UNITED STATES PATENT AND TRADEMARK OFFICE

| APPLICATION NO. | FILING DATE | FIRST NAMED INVENTOR | ATTORNEY DOCKET NO. | CONFIRMATION NO. |
|---|-------------|----------------------|---------------------|------------------|
| 10/802,177 | 03/17/2004 | Timothy W. Mehnert | 36185 | 3849 |

Office Action Summary

DETAILED ACTION

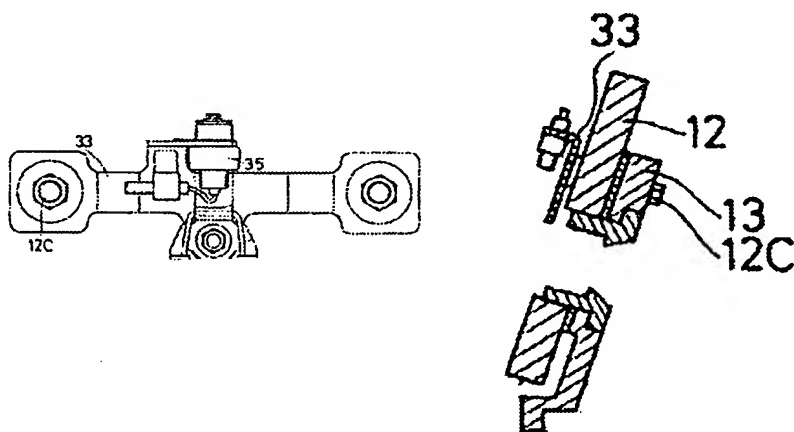
Re claim 6, the apparatus comprises a plurality of brackets [33,13], wherein a second bracket [13] and nut-bolt fasteners [12C] are employed to secure the first bracket [33] to the fixed portion of the watercraft. The switch – which itself is mounted on the first bracket – is therefore considered to be secured to the fixed portion of the watercraft by the first and second brackets. *(see simplified illustration below, as modified from figures 1 and 2).*

Further, the limitation "brackets are adjustable to adjust a sensitivity of the switch", as best understood from the specification, has been broadly interpreted to mean an "adjustment in

the position" of the switch. In this regard, a loosening of the bolts would allow both brackets to shift relative to the fixed portion of the watercraft, and would correspondingly change the position of the switch. Therefore, the brackets are considered as being adjustable by loosening of the nut-bolt fasteners, which will adjust the "sensitivity" of the switch, as broadly interpreted above.

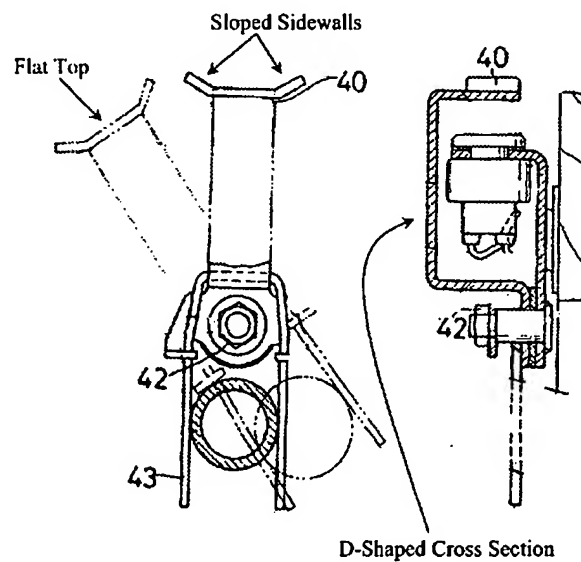
Re claims 7, 10 and 11, the cam includes two sloped sidewalls, joined by a flat top portion. The cam has a substantially D-shaped cross-section. (*see simplified illustration below, as modified from figures 2 and 3*)

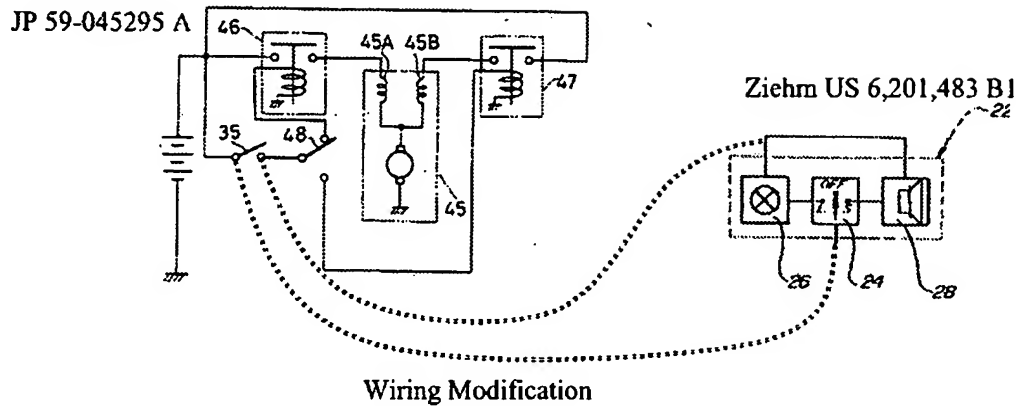
Ziehm shows boat having an indicator system to signal a centered position of a steering. The indicator system has an indicator light [26] that is activated by an electrically-connected switch [18] when the steering is in a centered position (col. 1, lines 36-48). The indicator light is mounted on a panel adjacent the boat steering wheel or helm station (col. 2, lines 63-64). The "panel" is considered to be an equivalent of a "dash".

It would have been obvious for one skilled in the art at the time of the invention to include an indicator light with the center-detecting switch of JP ('295), as taught by Ziehm. Having such indicator light would have provided a sure mechanism to alert an operator when it was safe to initiate a tilting operation of the outboard motor, regardless of the ambient light conditions. Such indicator light would have also provided a guidance mechanism for steering the watercraft in a straight direction, which would have further improved the operational safety (*see below for a simplified illustration of one possible modification of JP '295, as modified by Ziehm*).

Further, it would have been obvious for one to provide the watercraft of JP ('295) with a dash to locate the light, as taught by Ziehm. Having such dash would have allowed one to place all indicator devices together at a single location, thereby allowing easy monitoring of the watercraft operational conditions. Additionally, placing the indicator light at the dash would have ensured that the operator did not miss the steering centering signal.
